**CURATIVE AMMENDMENT FOR APPLICATION FOR
LICENSE (302-AM)**

WVOZ-AM AGUADILLA, PUERTO RICO

BL-20180911ADH (CP:BP-20170327AAF)

Changes made to EE -Proof of Performance:

Oct. 5/2018 (Curative Ammendment)

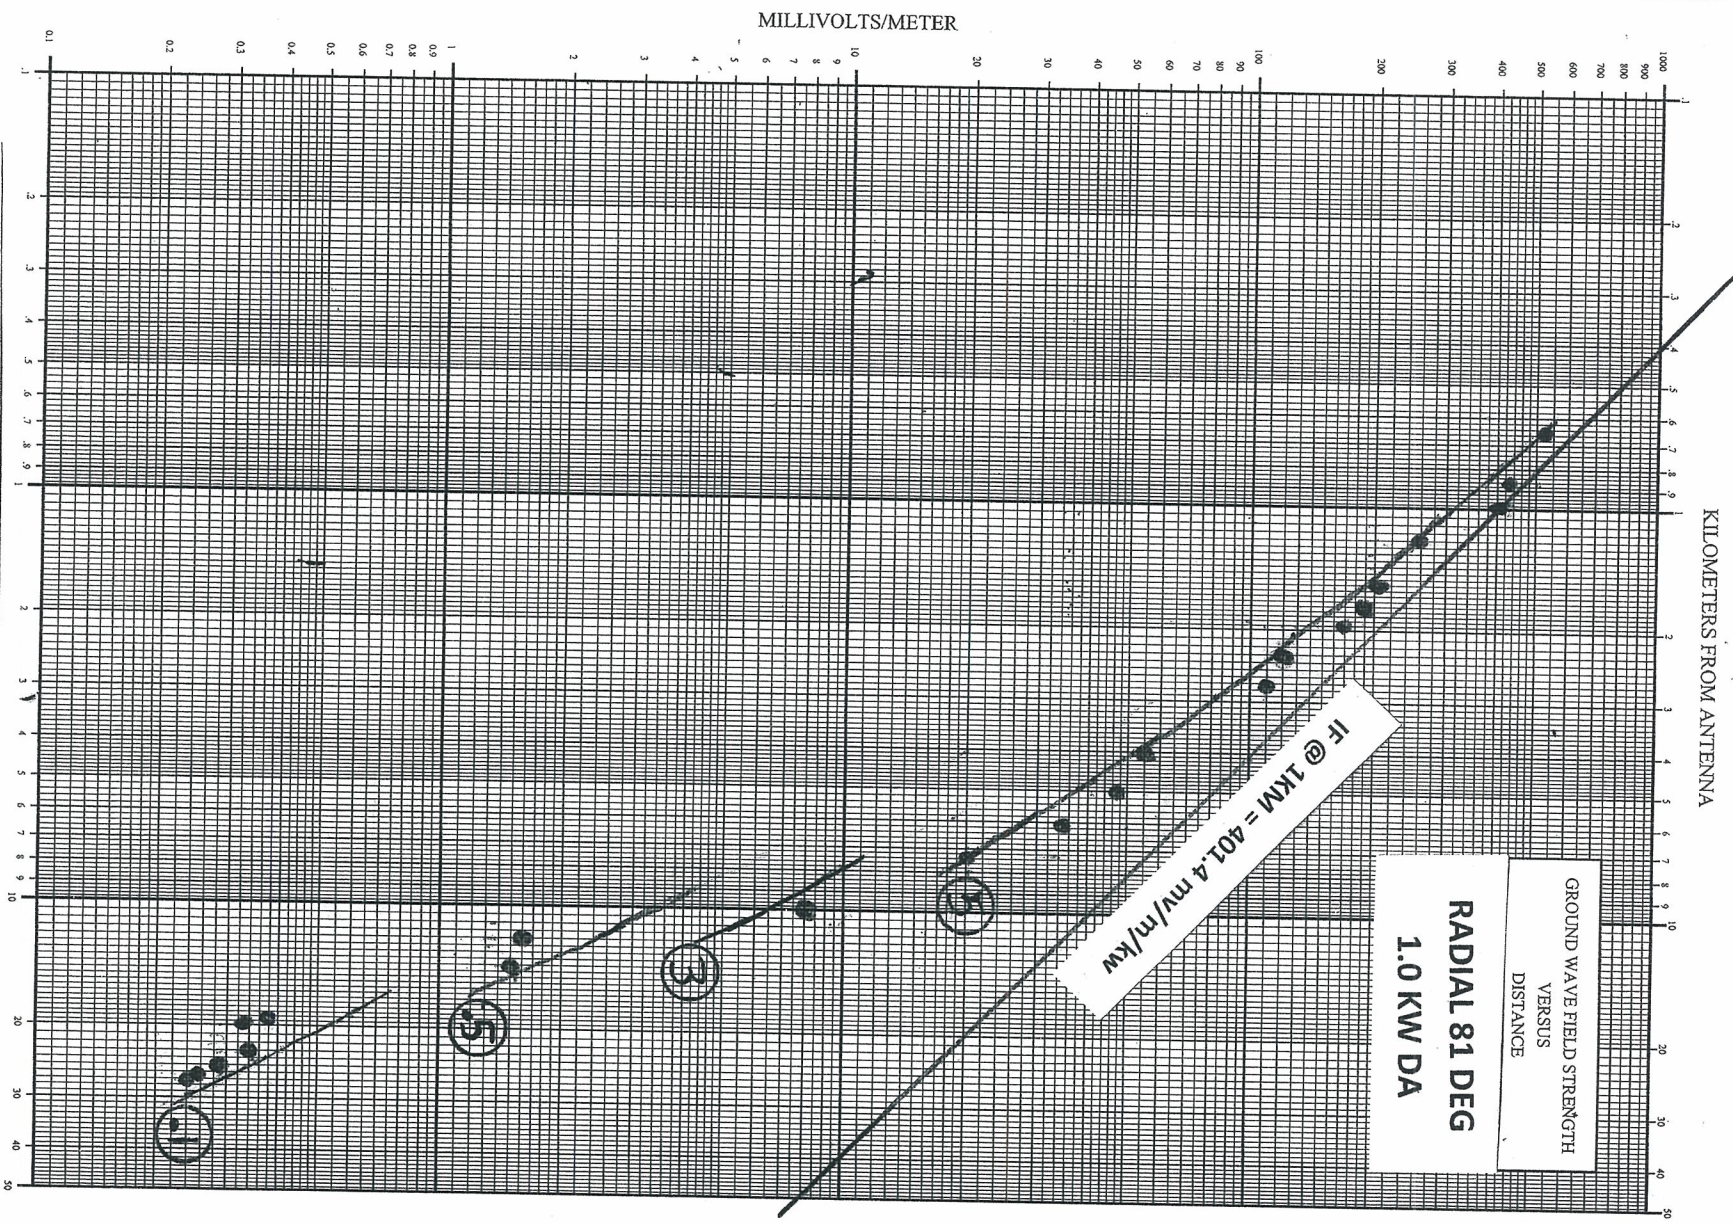
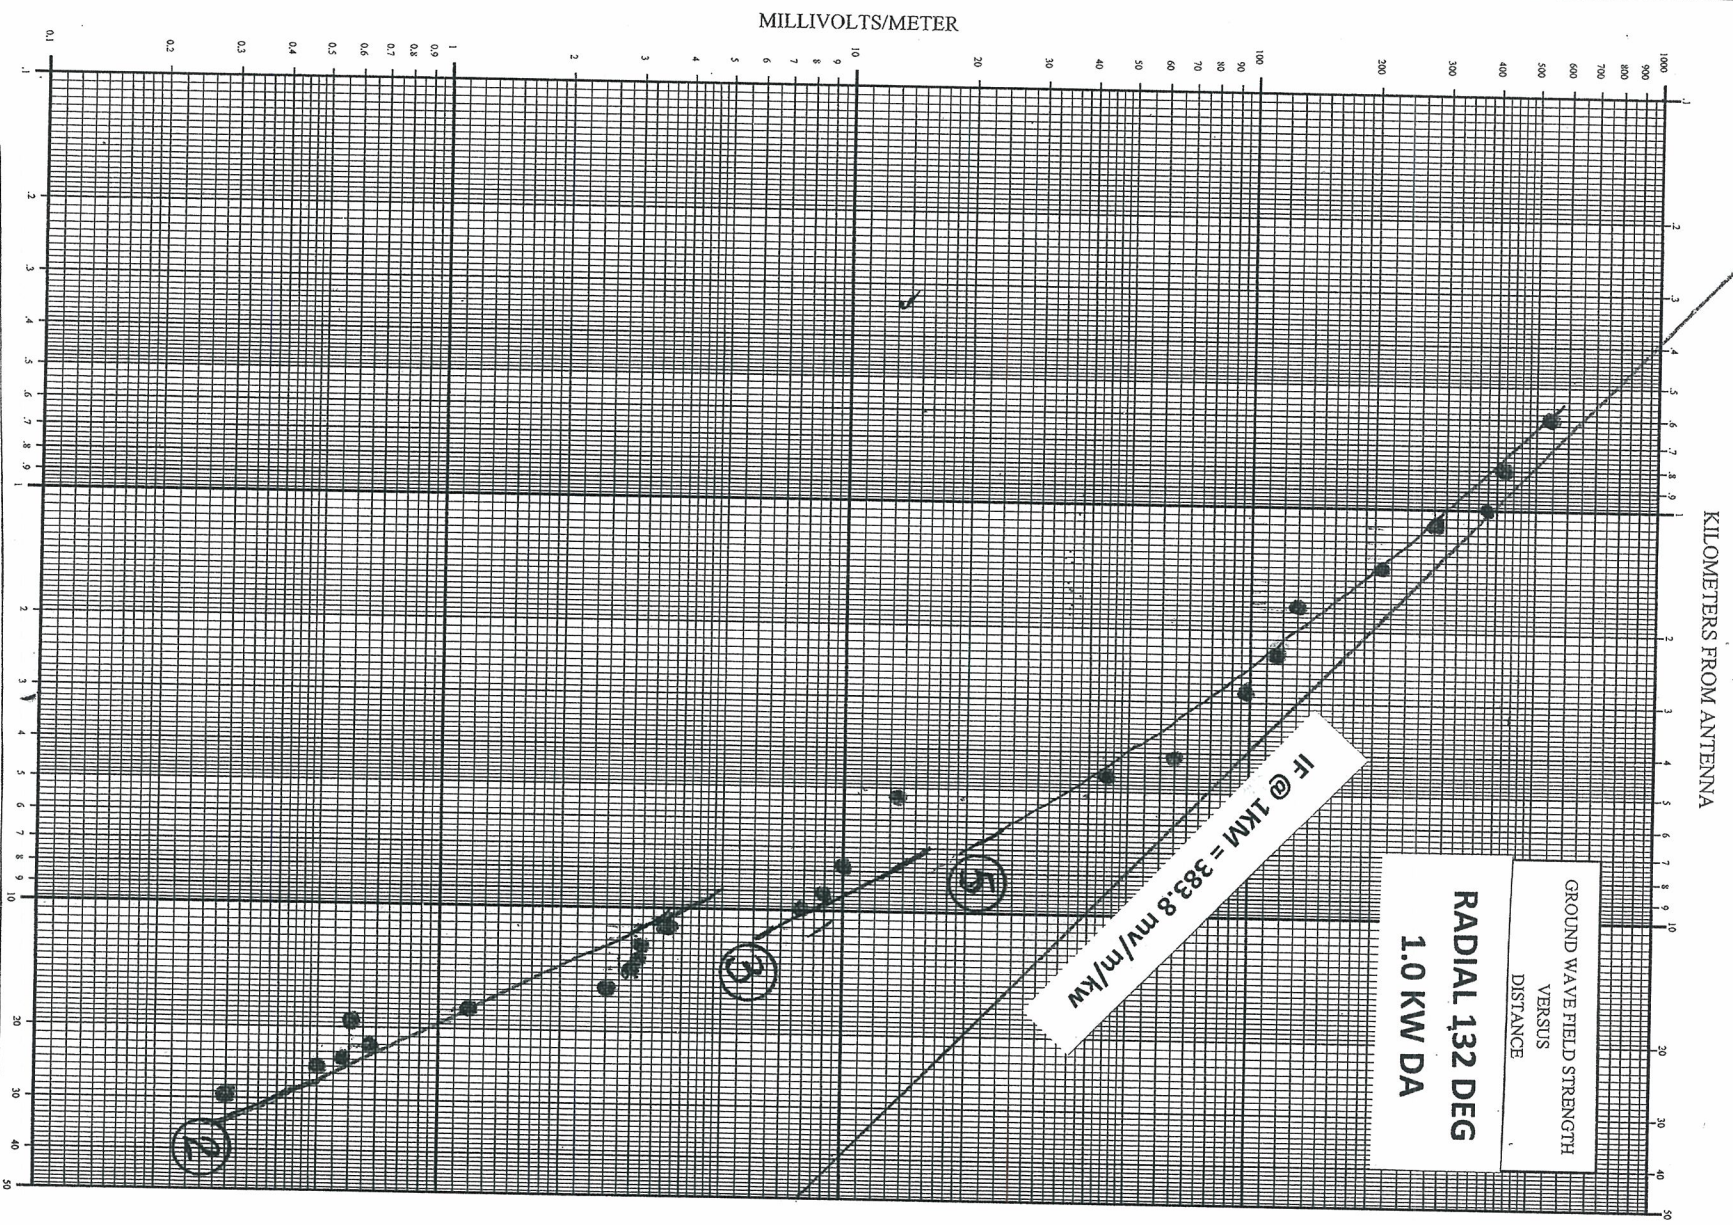
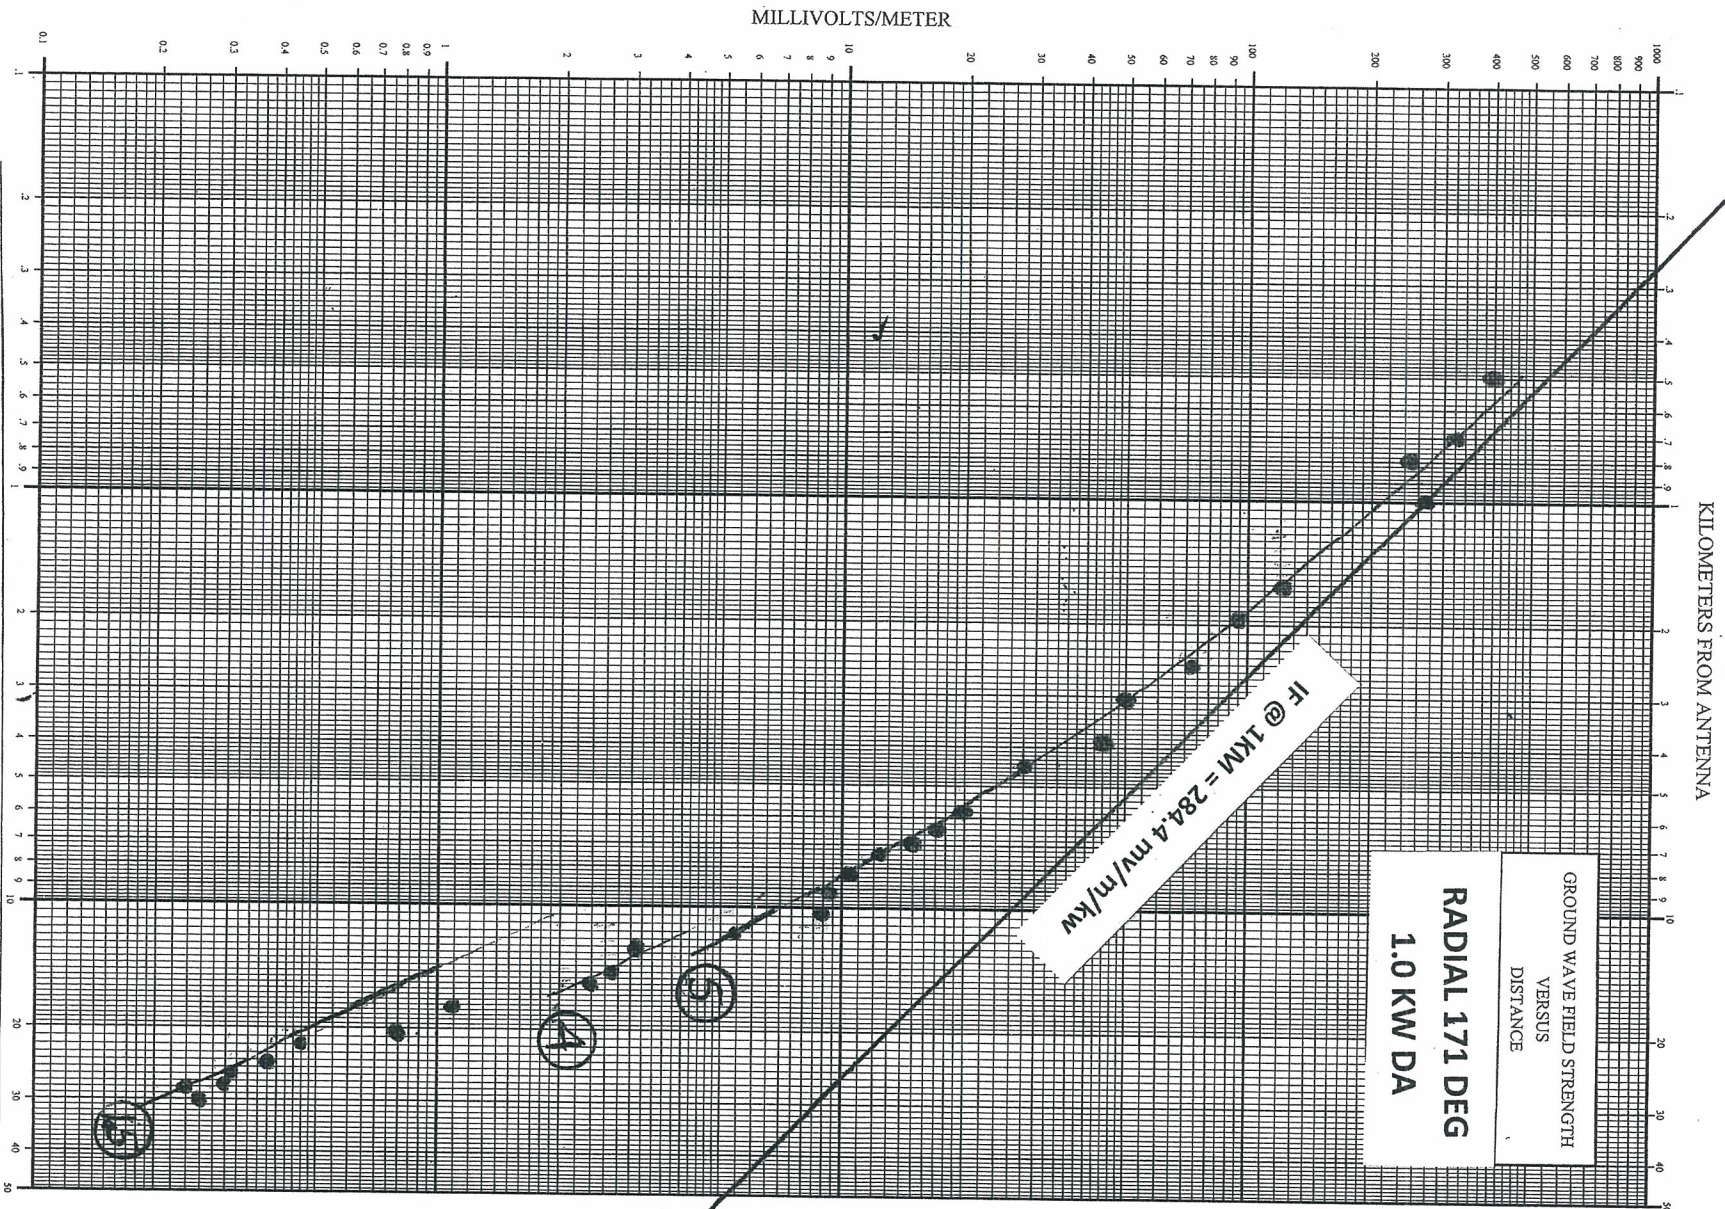
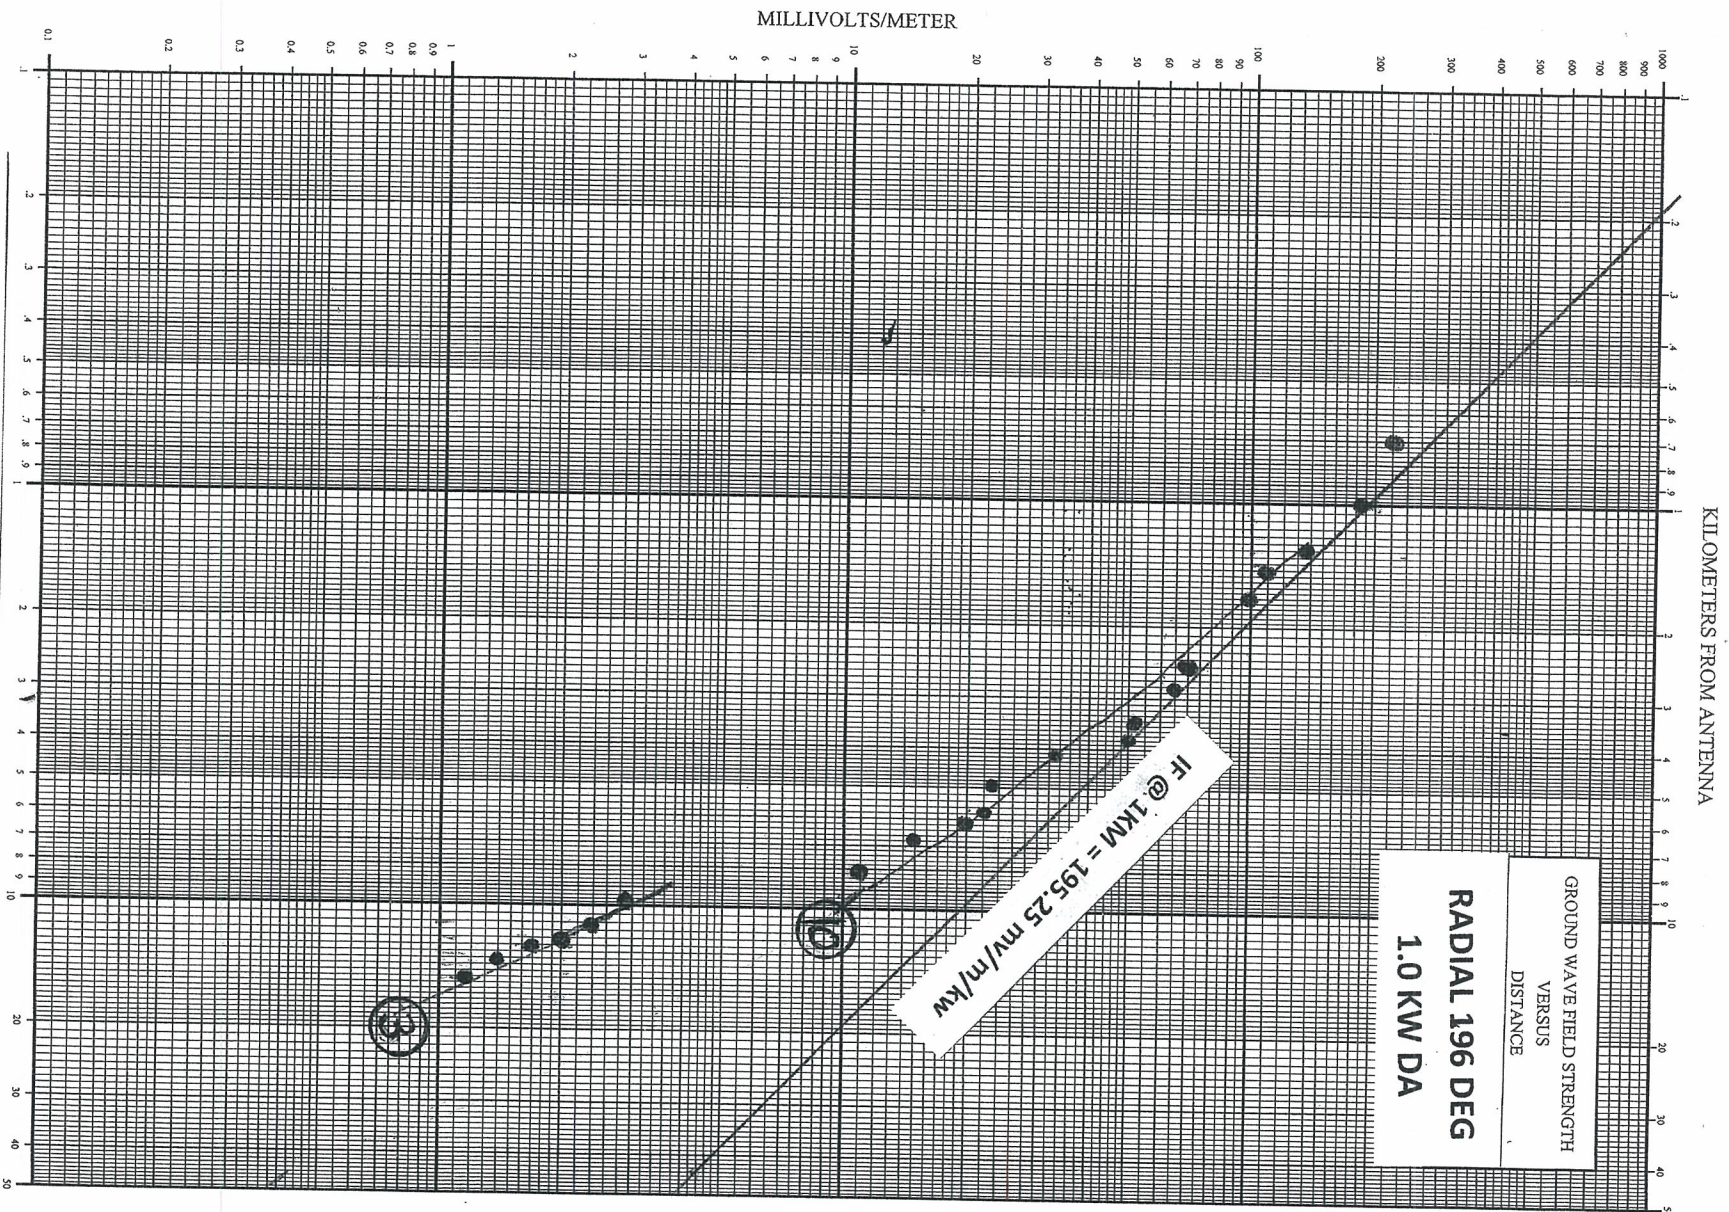
#1: By mistake, the secretary included as Figure 4 the incorrect set of graphs. The graphs that were included were an analysis tool and not the final graphs. The graphs incorrectly sent were used during the analysis process to figure out what the value for the points measured should most likely be after figuring out the attenuation curves by the best-fit method. That information was used to measure again most of the points that didn't fit on the conductivity curves selected for each radial to ensure the measurements originally taken were correct and that no error was made finding the correct point location and/or when taking the measurements.

The correct set of graphs is included for non-directional and directional. As you will see the conductivity curves chosen by the best-fit method are basically the same as the ones incorrectly sent. Although the email containing the PDF to the FCC was sent on Sept. 6/2018 and that same day the FCC emails back to us with the deficiencies, the paper filed copy was exactly the same as the one sent by email, since a curative amendment was immediately required by the FCC.

By this means, it is respectfully requested that the correct set of graphs along with the family of curves used to analyze them be made part of this curative amendment. (Please substitute the new set of graphs for each radial and insert Fig. 1 (Sheet 5A of 12: Family of curves for 1520-1600 downloaded from FCC page).
